GE Nuclear Energy

Subject: Supporting Radiological Information for License Renewal

RESPONSES TO REQUESTS FOR INFORMATION
REGARDING RADIOLOGICAL PROGRAMS

SKIN DOSE -- HIGHEST WORKER [1991-1995]

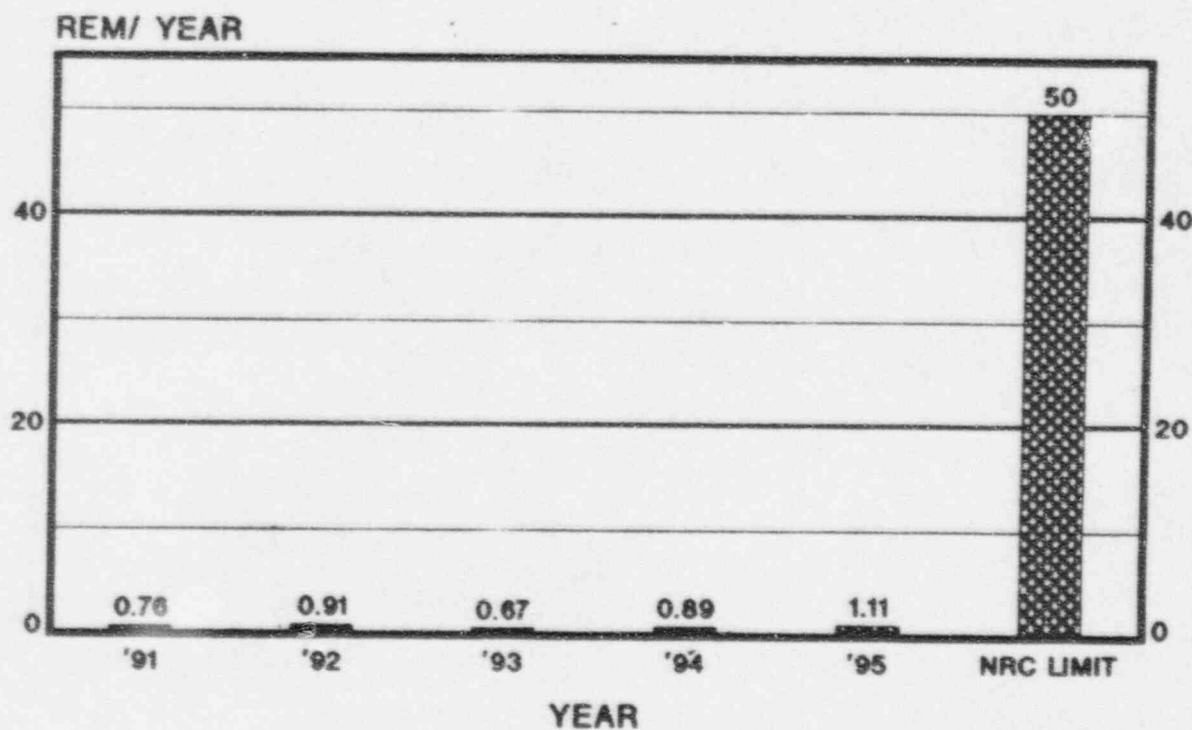
Enclosure 1 is a written response to three specific requests for information, and enclosure 2 is two additional charts you requested summarizing radiological trends.

This chart represents the highest external skin dose assigned to any individual. The individuals with the highest external skin dose assignments typically work in the ceramic operations.
